# 135 BROADWAY RESIDENTIAL TOWER

Design Review Submission  
Issued January 28, 2022  
Revised March 15, 2022

INSET AMENITY BALCONY AT THE NORTH FACADE LEVEL 6

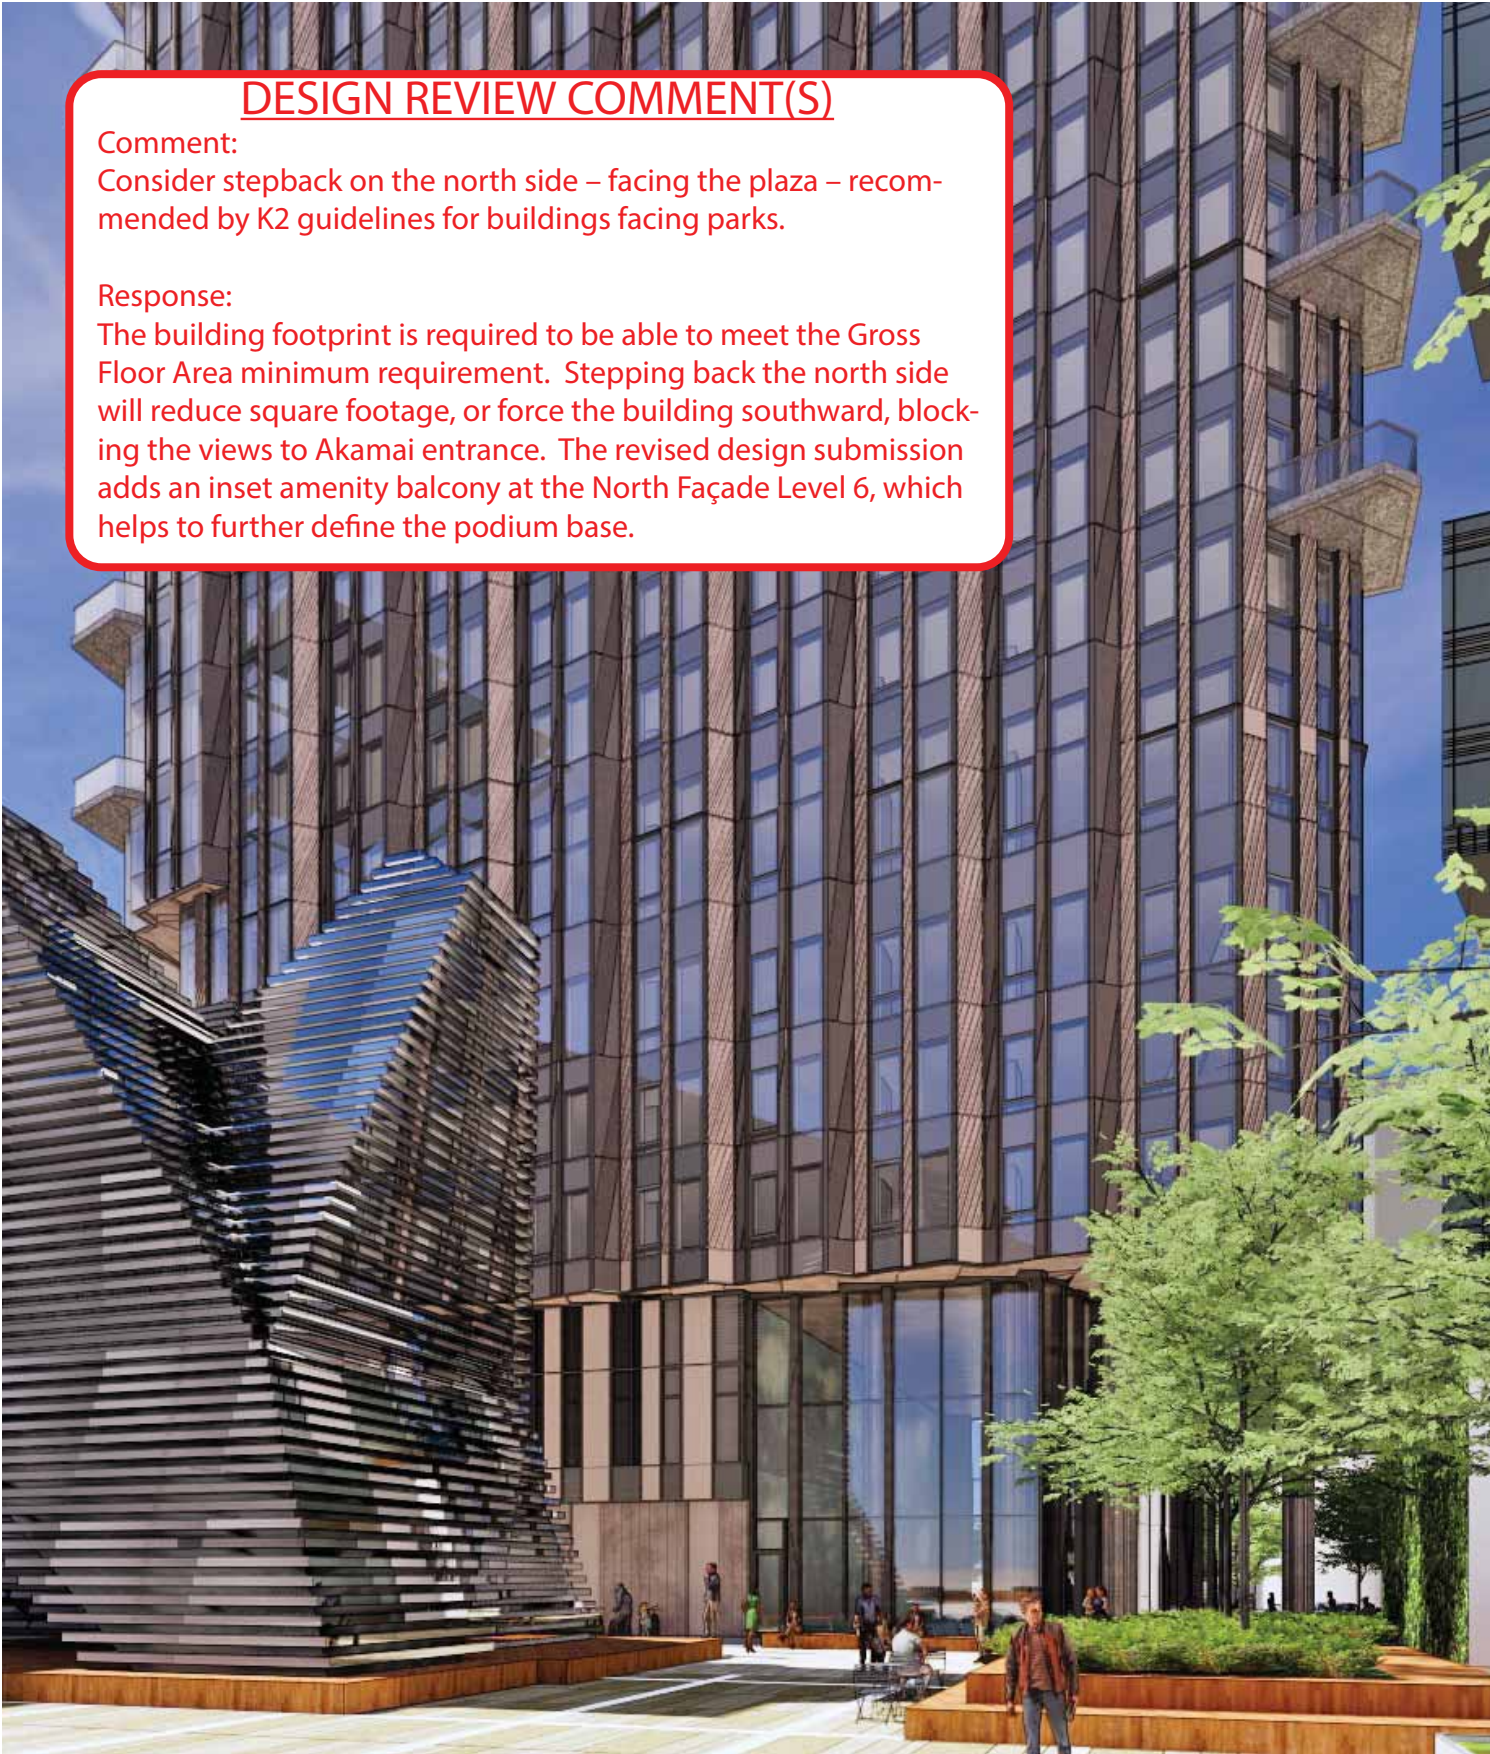
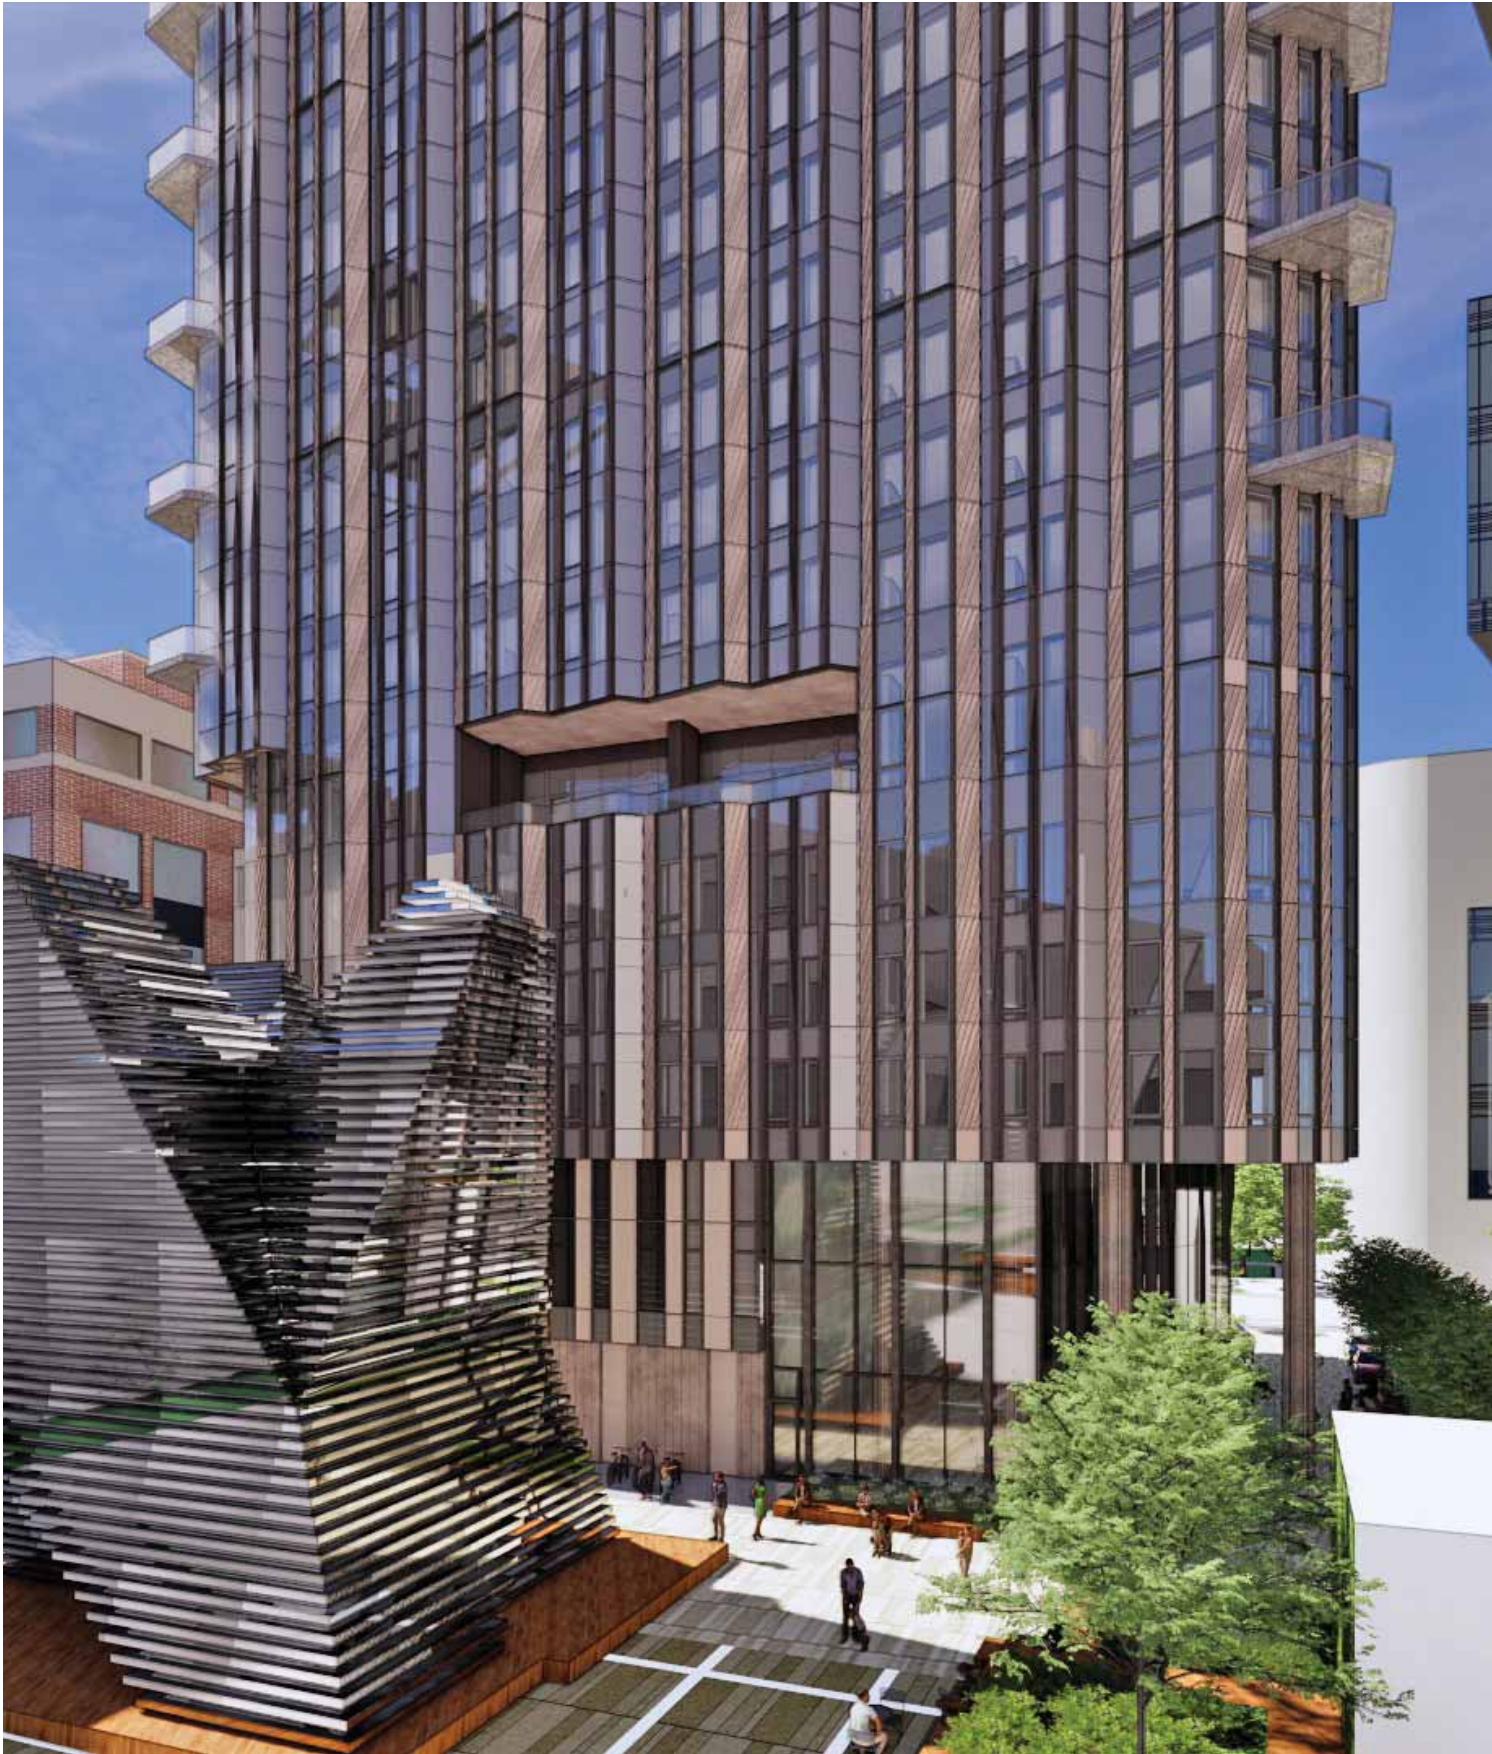
Comment:  
Consider stepback on the north side – facing the plaza – recommended by K2 guidelines for buildings facing parks.

Response:  
The building footprint is required to be able to meet the Gross Floor Area minimum requirement. Stepping back the north side will reduce square footage, or force the building southward, blocking the views to Akamai entrance. The revised design submission adds an inset amenity balcony at the North Façade Level 6, which helps to further define the podium base.
